# Access Compliance Report

### (Curb Ramps)

Intersection ID: N/A	Main Street: PROVIDENCE_RD	Cross Street: ARBORETUM_DR	Location: NE
ADA ID: 5F348FC8BBF6	Ramp Type: Perp	Initial Pass/Fail: Fail	Overall Compliance: No
Severity Score: 21.25			
Codes/Mitigation Info/Possible Solution		Field Measurements/Component Compliance

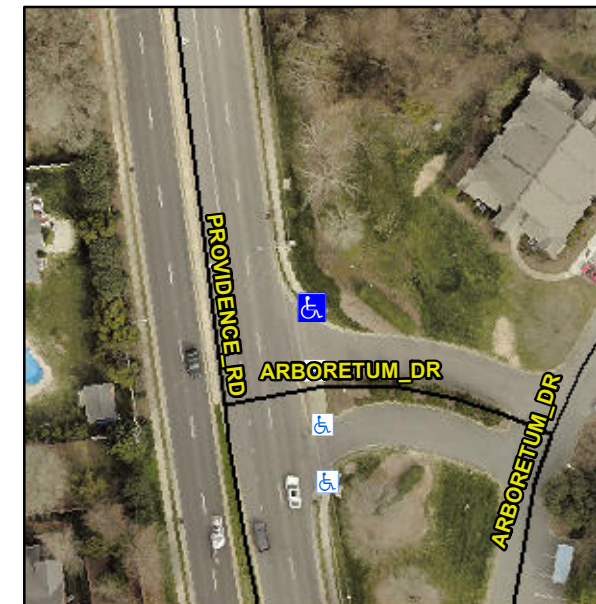
**Not Found, R304.5.1, R304.2.2**

Compliance	Description	Data	Compliance	Description	Data
N/A	Ramp Length (in)	71.5	No	Ramp Slope (%)	11.4
No	Ramp Width (in)	45.0	Yes	Ramp XSlope (%)	1.3
N/A	Flare Type LT	N/A	N/A	Flare Type RT	N/A
N/A	Flare Slope LT (%)	N/A	N/A	Flare Slope RT (%)	N/A
N/A	Flare Traversable LT?	N/A	N/A	Flare Traversable RT?	N/A
N/A	Landing Length (in)	N/A	N/A	DWS Provided?	N/A
N/A	Landing Width (in)	N/A	N/A	DWS Contrast?	N/A
N/A	Landing Slope (%)	N/A	N/A	DWS Length (in)	N/A
N/A	Landing X Slope (%)	N/A	N/A	DWS Full Width?	N/A
N/A	Landing Curb? (Y/N)	N/A	N/A	DWS Offset (in)	N/A
N/A	Shared Landing?	N/A			
N/A	Gutter Ponding?	N/A	N/A	Gutter Slope (%)	N/A
N/A	Gutter Lip Ht (in)	N/A	N/A	Gutter X Slope (%)	N/A
N/A	Painted X Walk1?	No	N/A	Painted X Walk2?	N/A
	X Walk 1 Direction	To S		X Walk 2 Direction	N/A
N/A	X Walk 1 Width (in)	N/A	N/A	X Walk 2 Width (in)	N/A
	X Walk 1 Slope (%)	0.3		X Walk 2 Slope (%)	N/A
	X Walk 1 X Slope (%)	0.2		X Walk 2 X Slope (%)	N/A

**Remove & Replace Entire Ramp.**
